MISSION TRAIL COMMUNITY LIBRARY WILDOMAR, CALIFORNIA

TITLE SHEET

AS-BUILT

SHEET TITLE
PLANTING PLAN

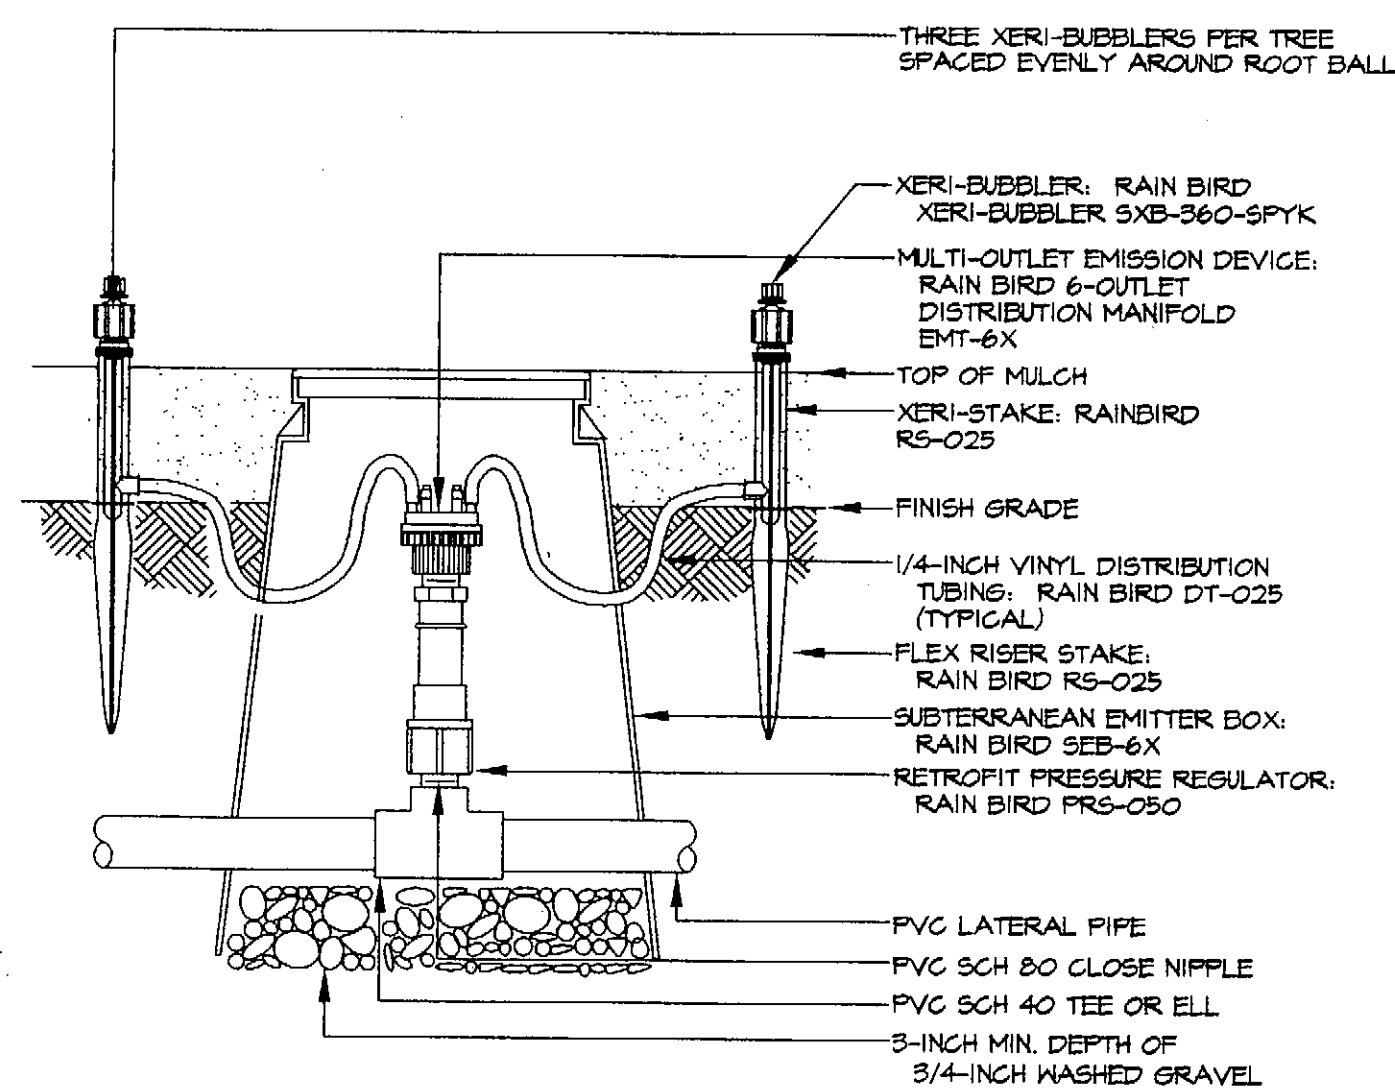
6/1/00 DELETE PLANTS IN PARKING AREA

SITE PLAN

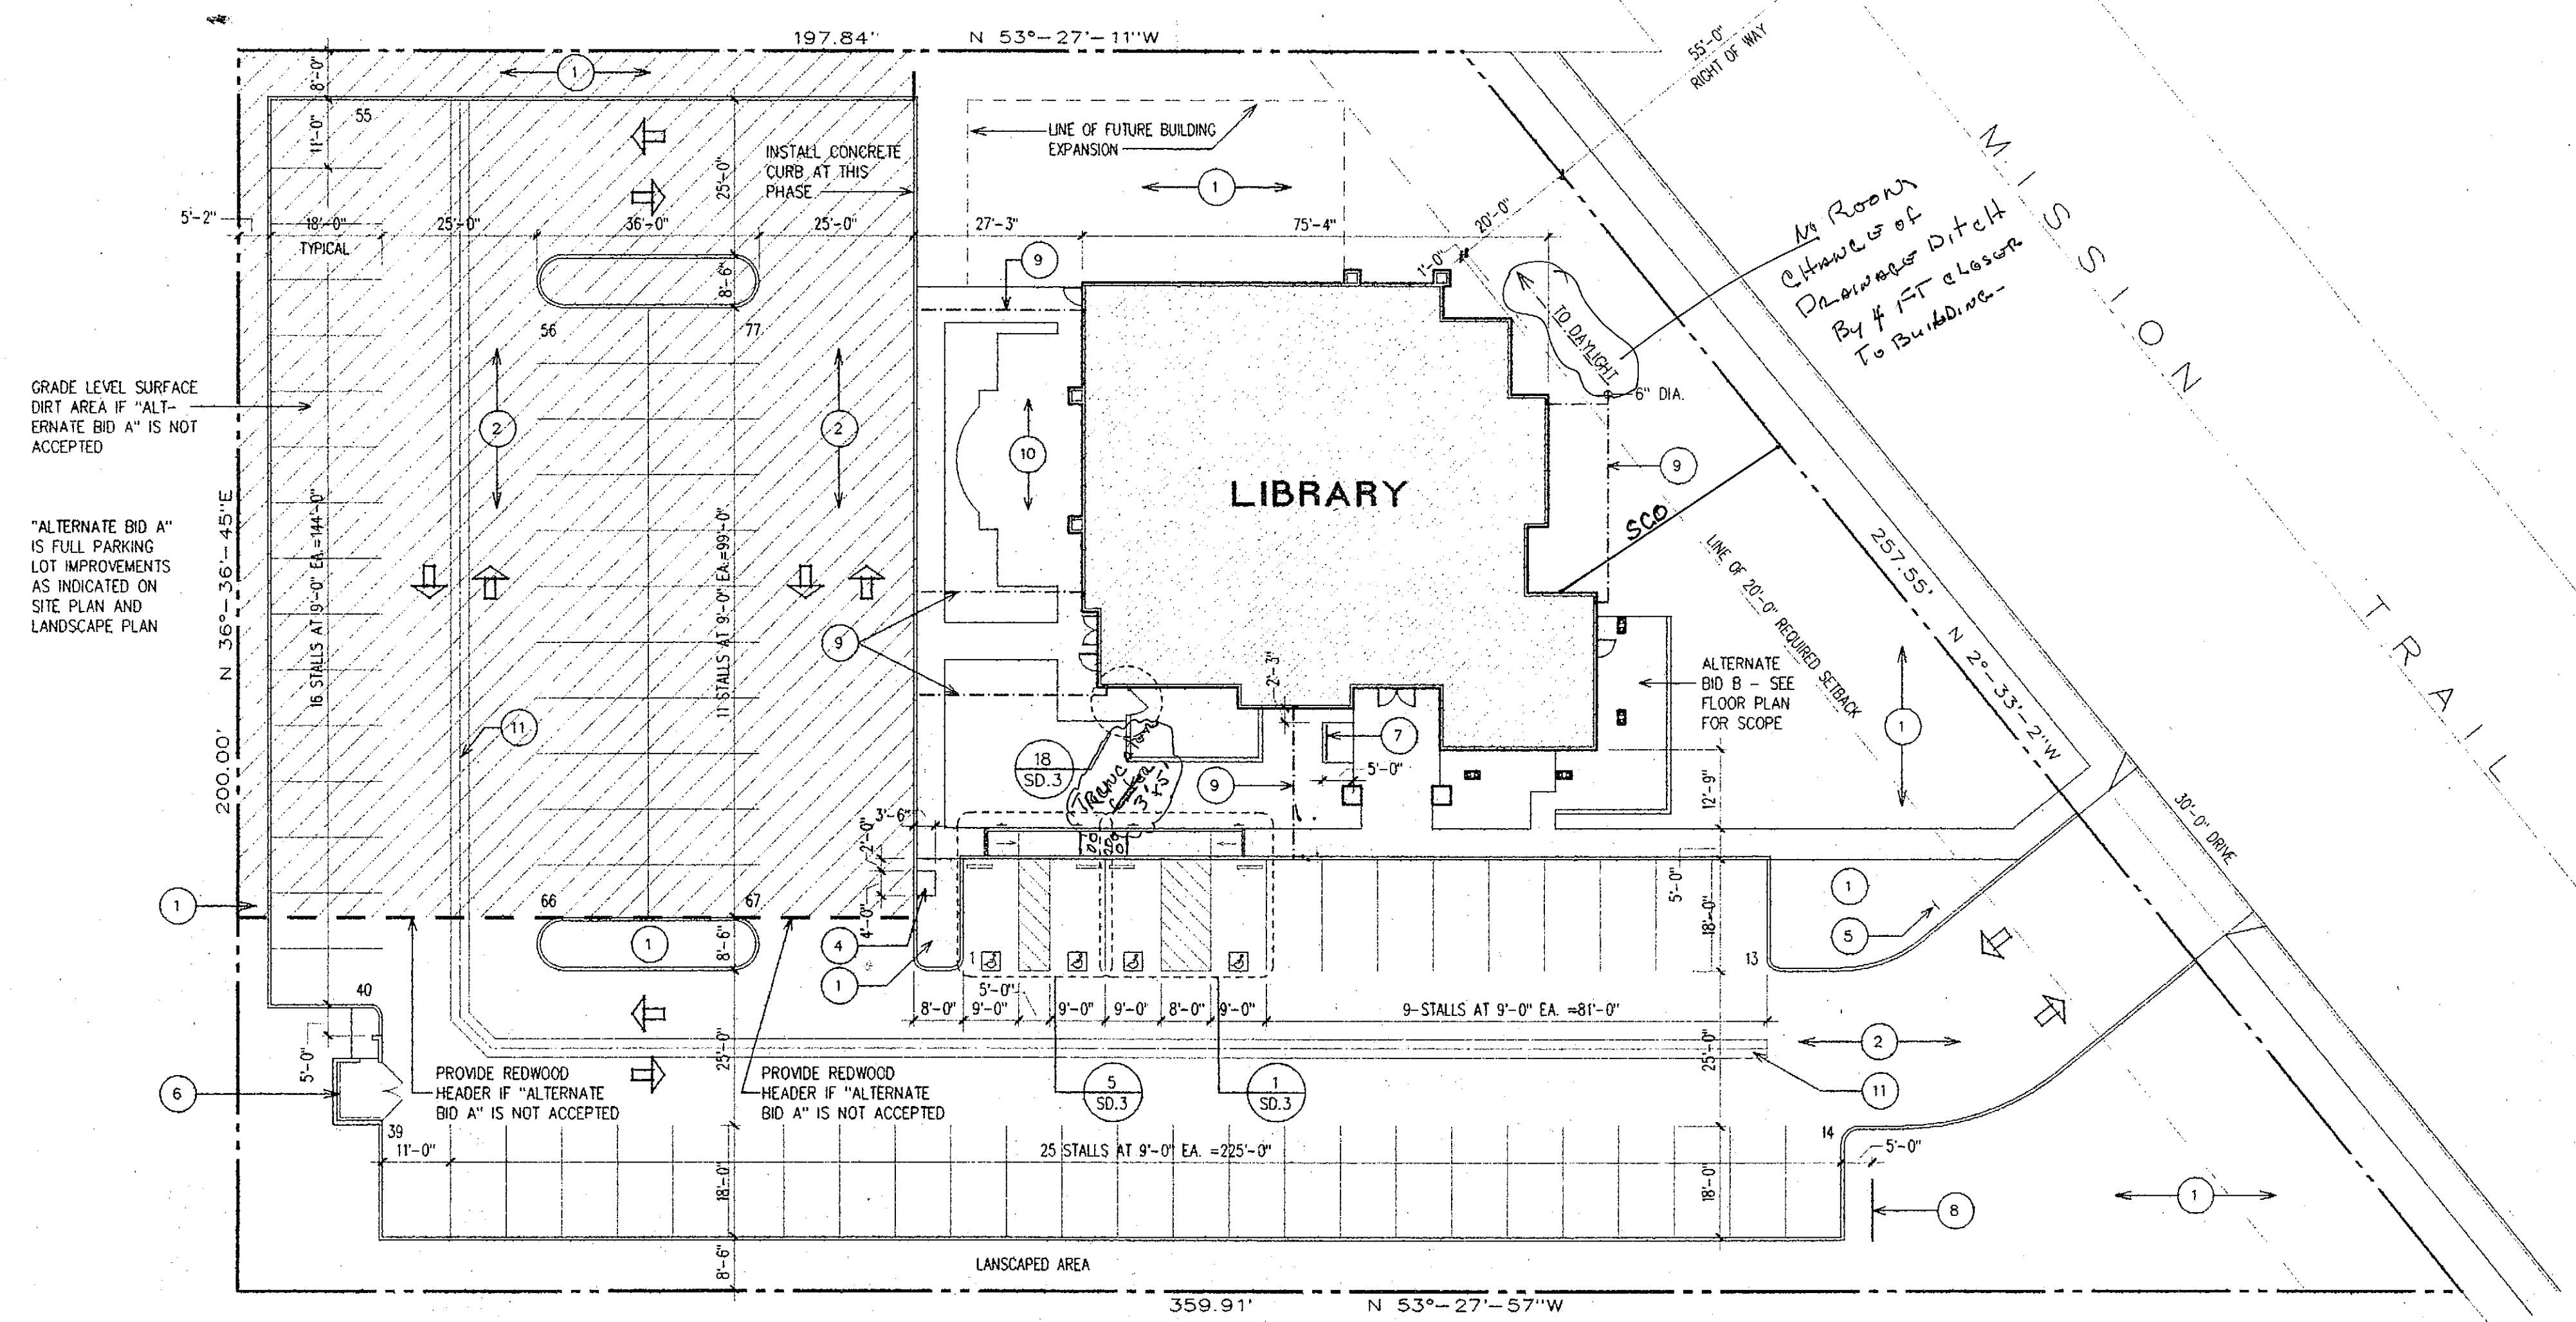
Wrong Detail

In Room
Change of
Dimensions
By 4 FT closer
To Building

FOUNDATION PLAN
SCALE 3/16"=1'-0"

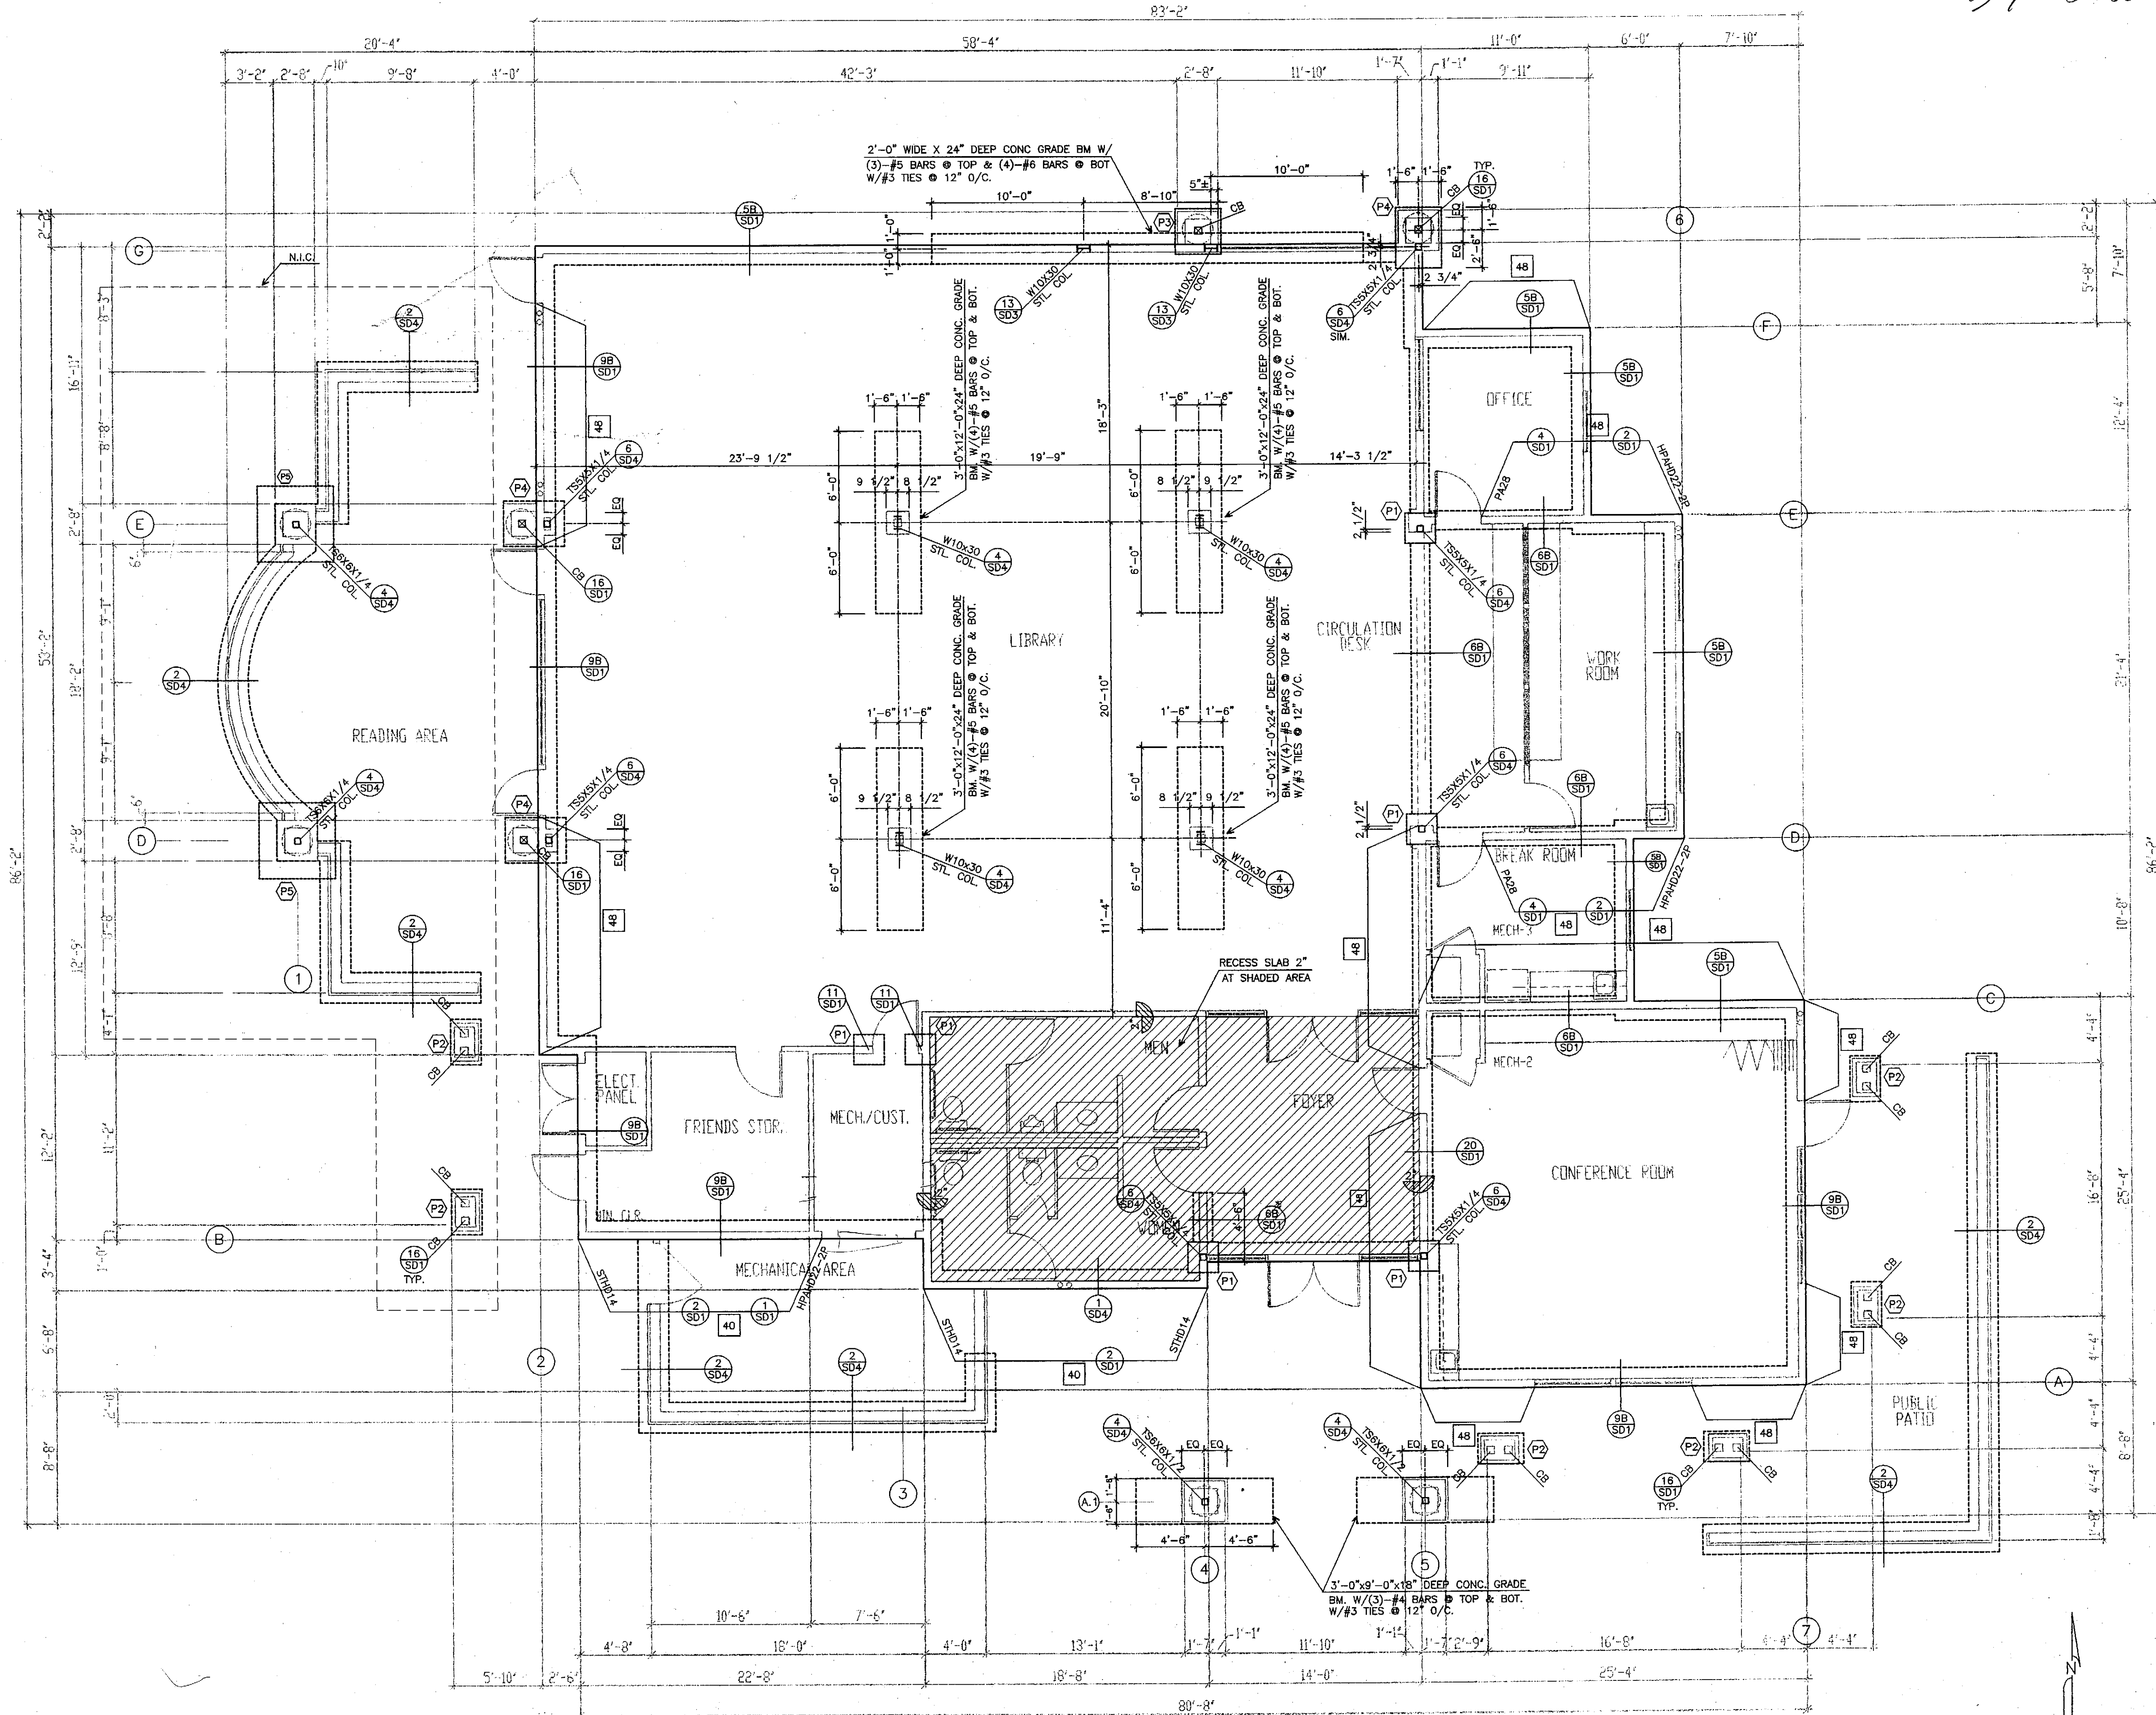
BY: B2200 G- Pad Footings OK To Pour pending app
